MS9443
AMENDMENT 1
8 JULY 2003

BOLT, MACHINE - STEEL AMS 6304, DIFFUSED NICKEL-CADMIUM PLATED,
HEXAGON HEAD, DRILLED, .375-24 UNJF-3AThis amendment forms a part of MS9443, dated 21 December 1962, and is approved for use by
all Departments and Agencies of the Department of Defense.

Sheet 1

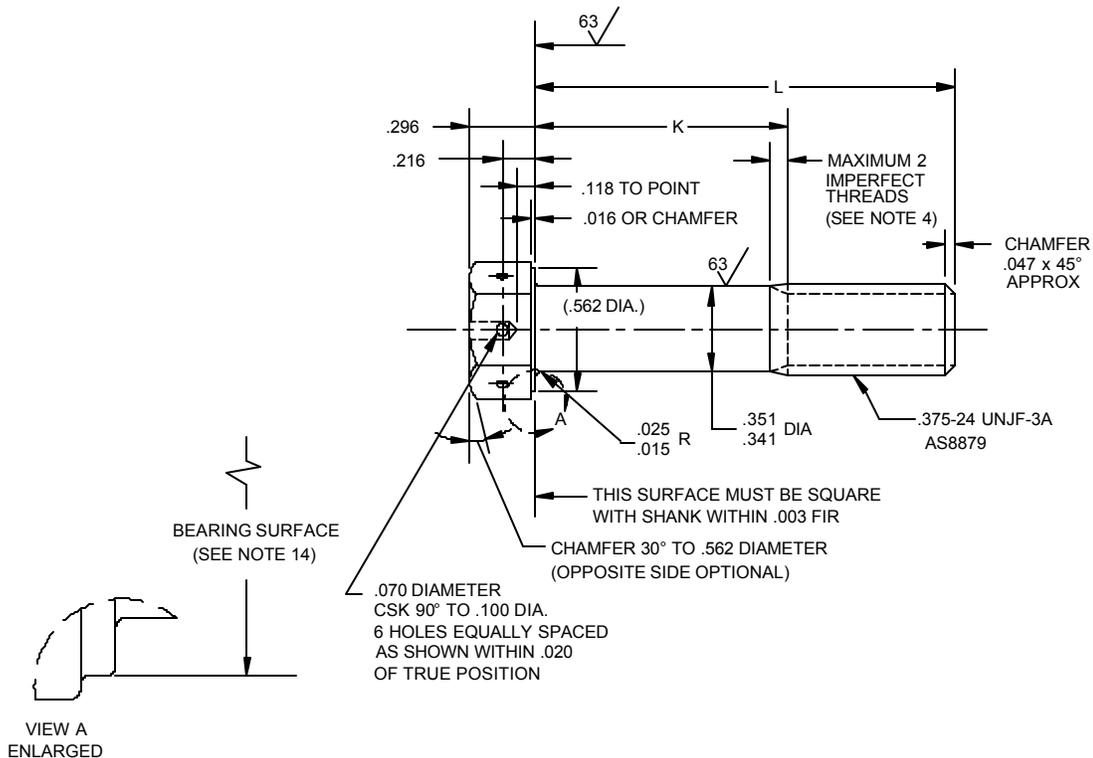
In drawing: Replace front view with this drawing and add View A.
